The following sections are added to the HF SSB transceiver 8525B/8528 series Technical Service Manual, Codan part number 15-02036 Issue 6, November 1995.

Service bulletin Page 1 of 2

17-00107 ISSUE 1 October 1991

### 9103 Automatic Antenna Tuner - Serial Nos A1312 - A1342

SYNTHESISER

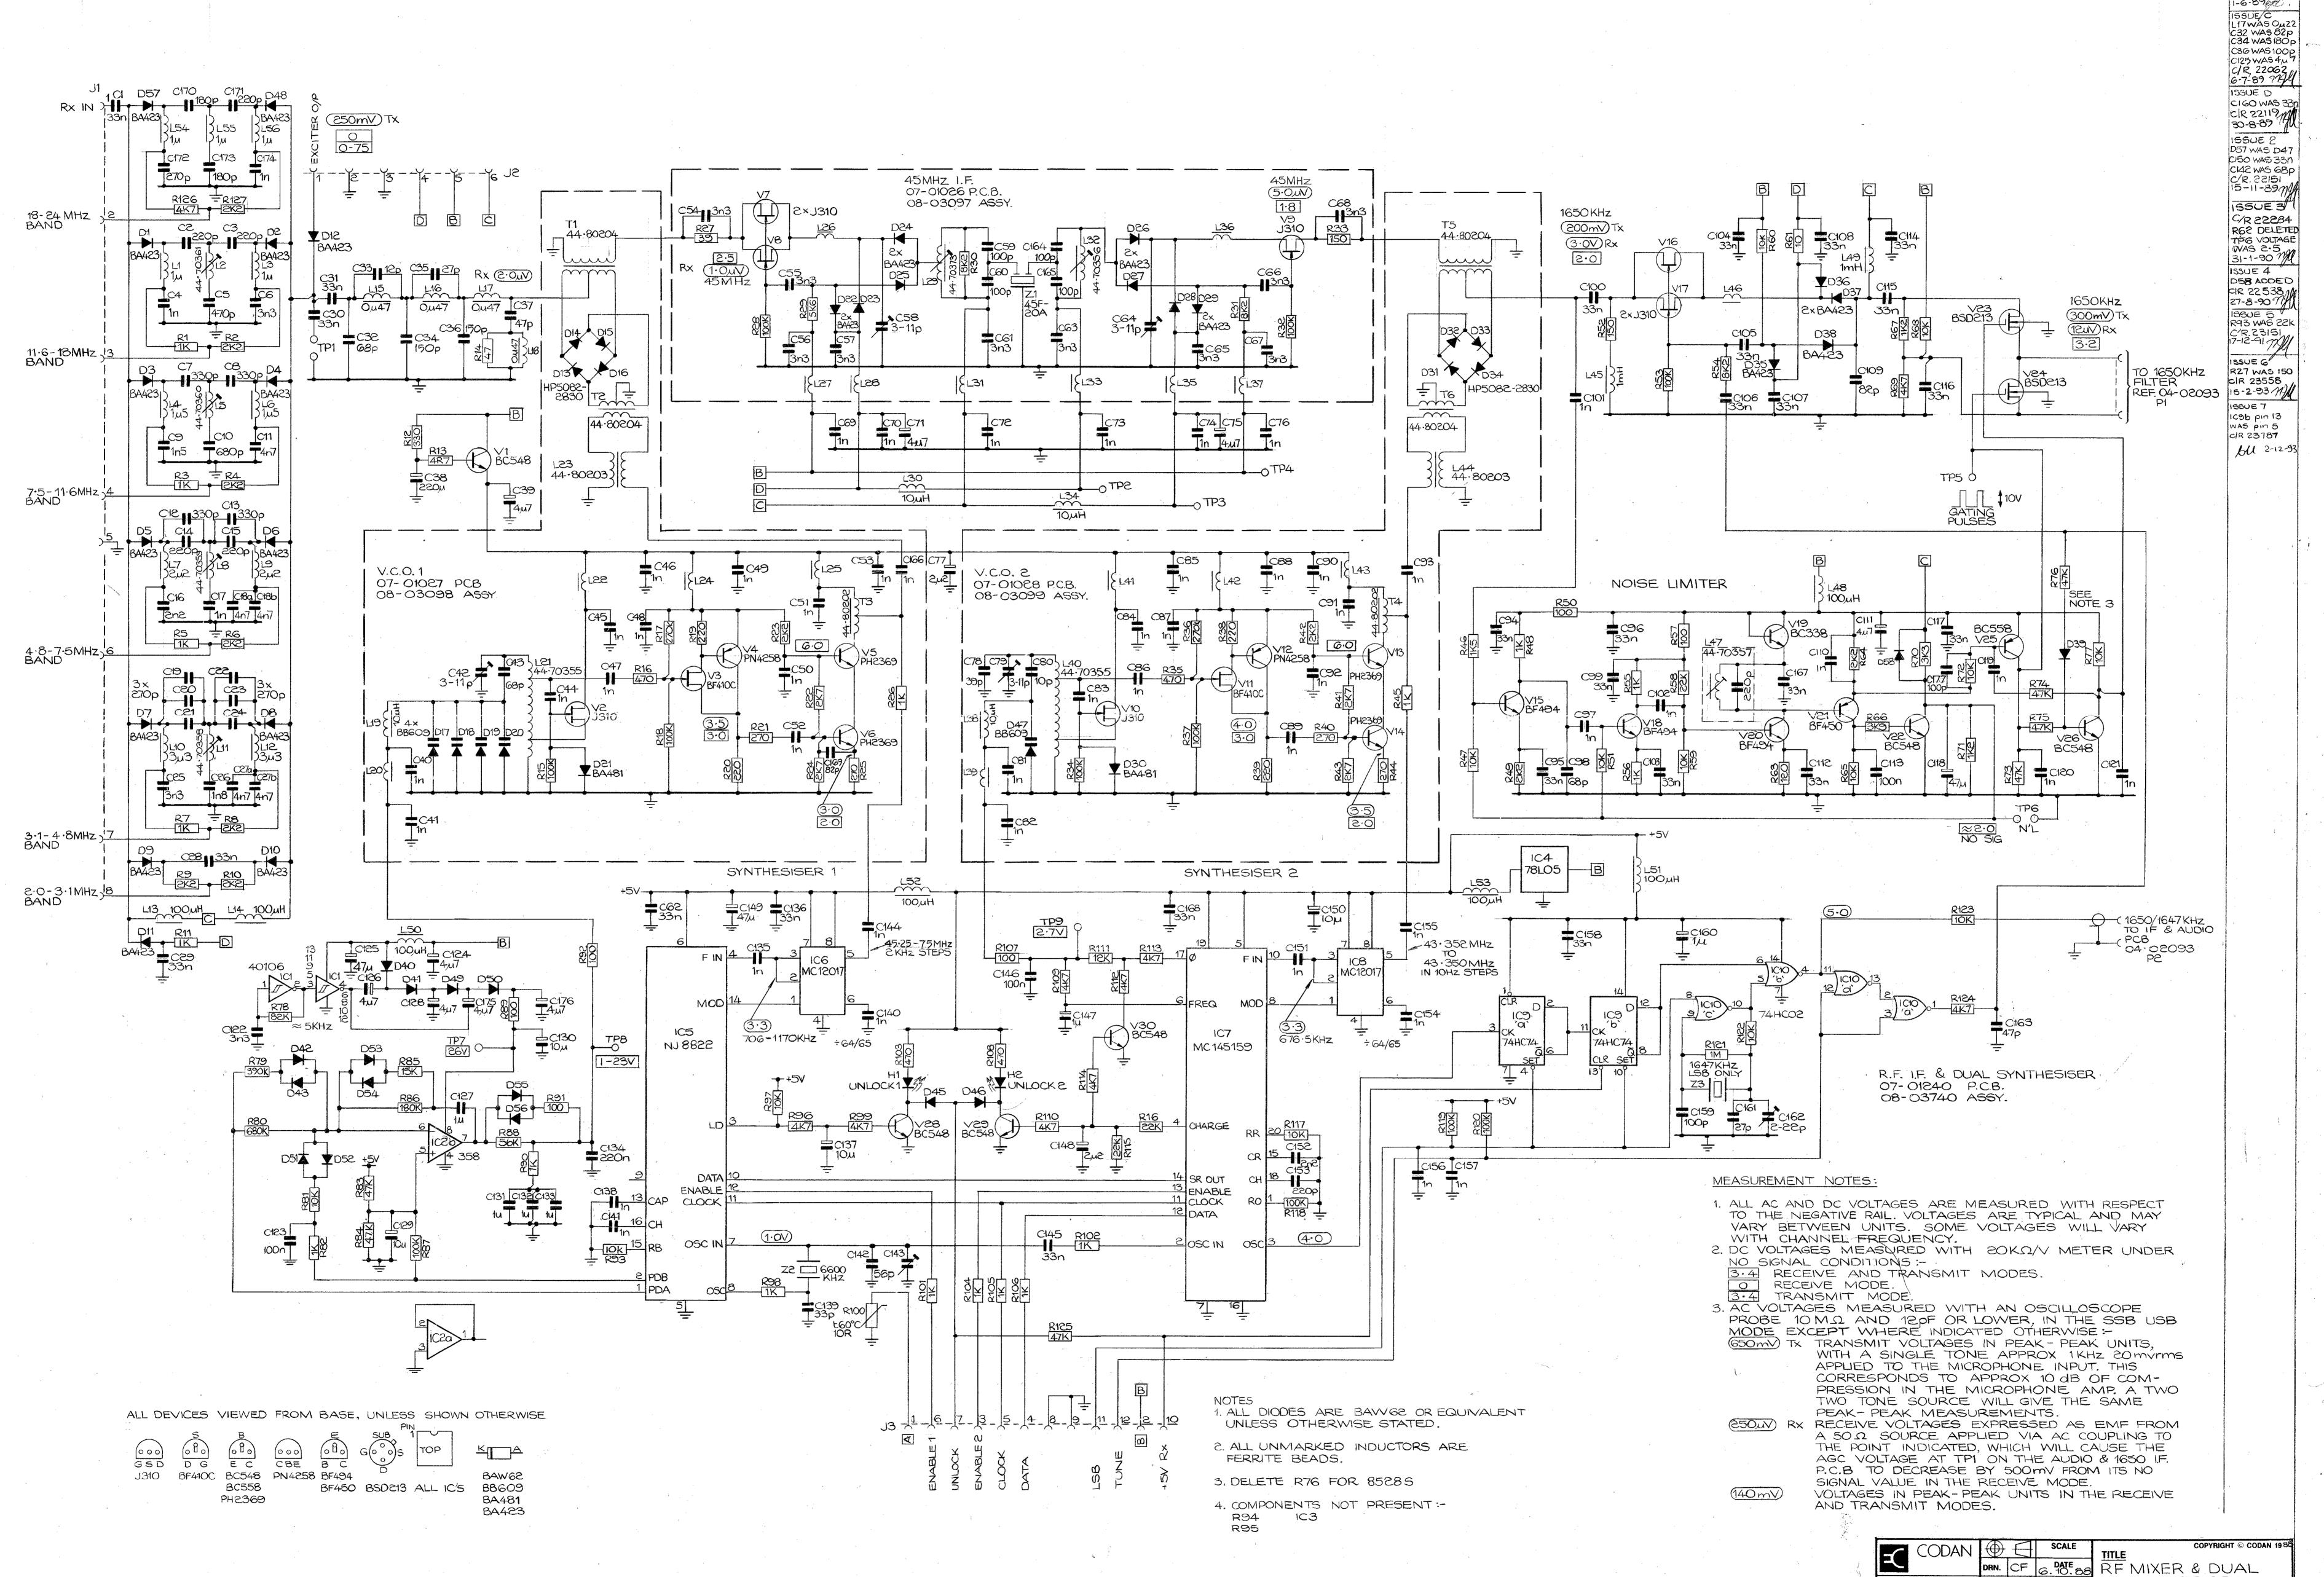
ISSUE B R79 WAS 100K

CODAN	SCALE TITLE COPYRIGHT © CODAN 19
	DRN. O.R. 8-9-88 PCB FAN CONTROLLER
MATERIAL	CHKD. 7741 11-10-89
	APPD. 74 14-9-89 DRAWING/DOC NO.
FINISH	TOLERANCES UNLESS OTHERWISE STATED
	2 PLACES DEC ± 1 PLACE DEC ± ANGULAR ±  ISS  OF 1

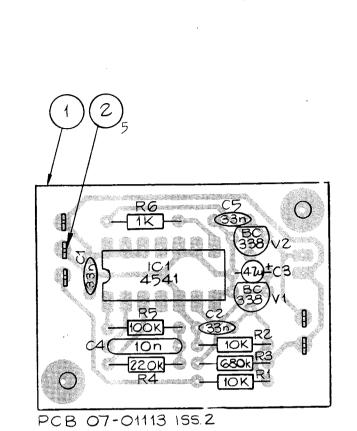
ISSUE B
R4 VALUE
CHGD FROM
200K
C/N 21697
24-11-88
ISSUE 2
C3 WAS 242
R3 WAS 470K
CIR 23584
24-2-93/

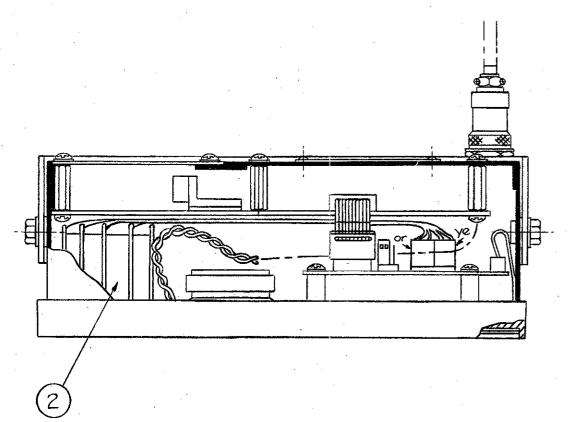
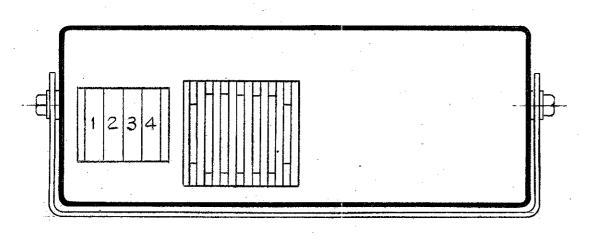
2.C/R. 21367 22-3-88 9/0 185UE 3 TWO UNUSED HOLES ADDED TO PIB. C/R 23793

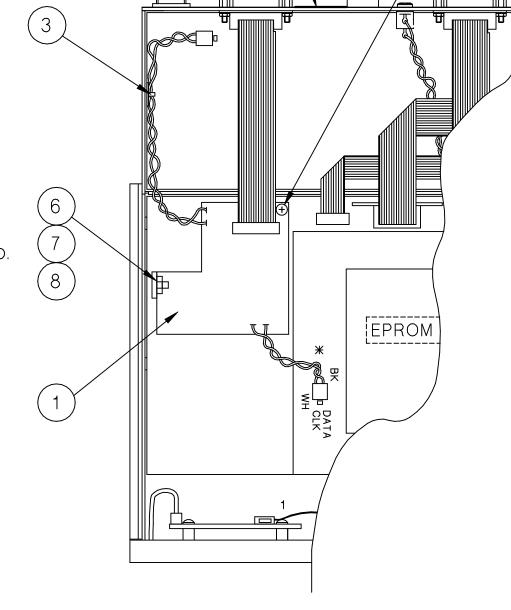
ISSUE 1 NOTE 2 CHANGED ITEM 5 DELETED. C/R 23769 CM 1-11-93

Figure 1. Part of 9103 Tuner Assembly

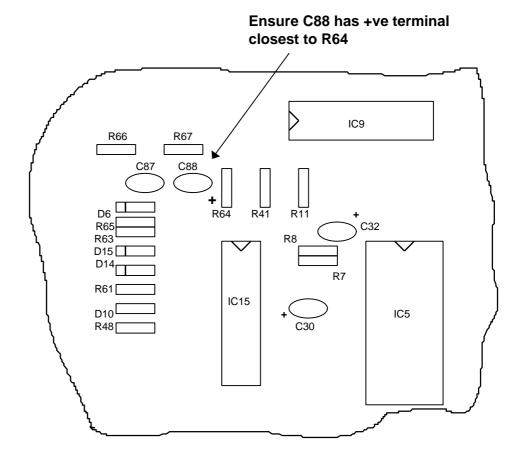
An error has been discovered on the PCB silkscreen whereby Capacitor C88 ( $2.2\mu$ F) may have been inserted incorrectly. The silkscreen identifies the +ve terminal of C88 closest to capacitor C87 and is incorrect. The +ve terminal should be located closest to Resistor R64.

On units with Serial Nos greater then A1342 the error has been rectified and the incorrect identifier on the PCB removed however, the possibility exists for some units in the Serial No. range A1312 - A1342 to have had the capacitor wrongly inserted. Whilst this may not be apparent from tuner operation, the capacitor may break down over a long period of time resulting in poor scan operation.

Owners of Tuners with Serial Nos in the above range are advised to check the orientation of capacitor C88 and replace it where incorrect. This can be accomplished by the following:

- I. Remove 10 screws securing the Tuner lid
- II. Remove 4 screws securing the shielding plate
- III. Check the orientation of Capacitor C88 as per the attached Fig 1 and if incorrect -
  - (a) Remove 4 screws securing the PCB, desolder Capacitor C88 and replace it with one correctly oriented.
  - (b) Carefully scratch off the + sign on the PCB adjacent to C88 to avoid future confusion;
  - (c) Replace the PCB
- IV. Re-assemble the Tuner
